From: Fawal, Margaret K. <MKFawal@Venable.com>
Sent: Friday, May 31, 2019 4:50 PM
To: Wayland, Joshua
Cc: Floyd, Kathryn K.; Rutson, Vicki; Gosselin, Danielle; 'Michael McKee'
Subject: FD 36284 - Supplemental Response to Information Request 1
Attachments: Supplemental Response to OEA Informatoin Request #1 5.31.2019.pdf

**Seven County Infrastructure Coalition's First Supplemental
Response to the STB Office of Environmental Analysis
April 12, 2019 Request for Information # 1**

Seven County Infrastructure Coalition - Uinta Basin Railway: Evaluation of Potential Route Alternatives

Figure 1: Identified Routes

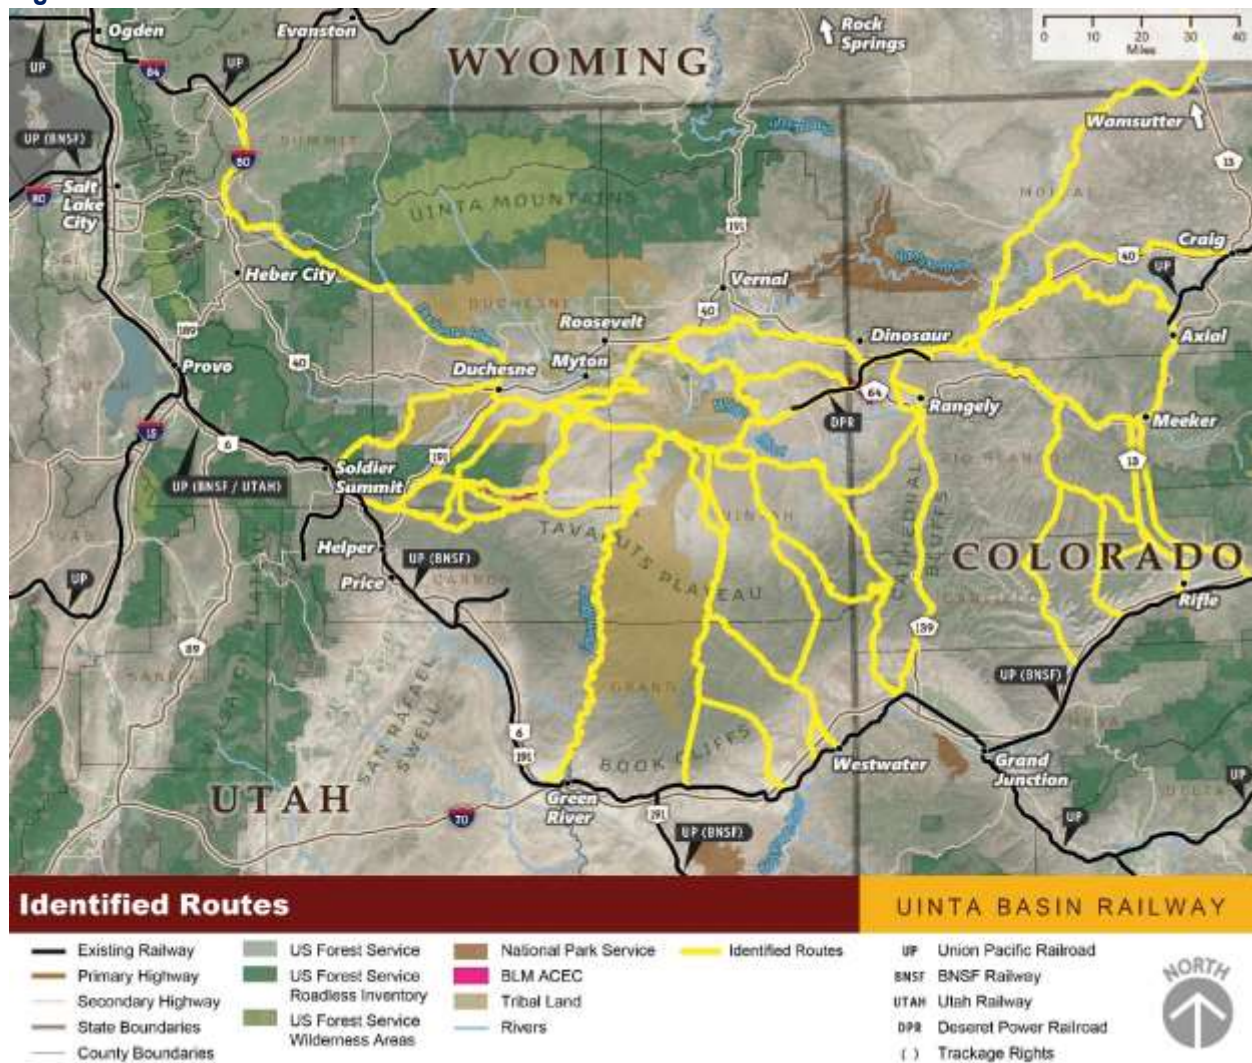
OEA Information Request: *Page two of [the Uinta Basin Railway Evaluation of Potential Route Alternatives] document discusses the rational for the elimination of 21 routes from further consideration using the four criteria as rational for dismal. OEA requests further details, specifying the reason(s) each route was dismissed.*

Coalition Response: Provided as Attachment 1 to this response is an updated version of the *Uinta Basin Railway Evaluation of Potential Route Alternatives* containing additional details regarding the elimination of 21 routes from further consideration in the initial screening process.

After identification of these 29 routes, HDR began the initial screening process. Based on the screening criteria developed for the project, 21 routes were removed from further consideration as they (1) did not meet the operating parameters established in the Operating Basis of Design; (2) had a significantly higher cost of construction, compared

to the other routes; (3) ran through significantly more areas of urban and residential land use, compared to the other routes; and/or (4) ran through significantly more areas that are environmentally sensitive or have substantial cultural resources, compared to the other routes. The initial screening process is described in more detail in Section III below.
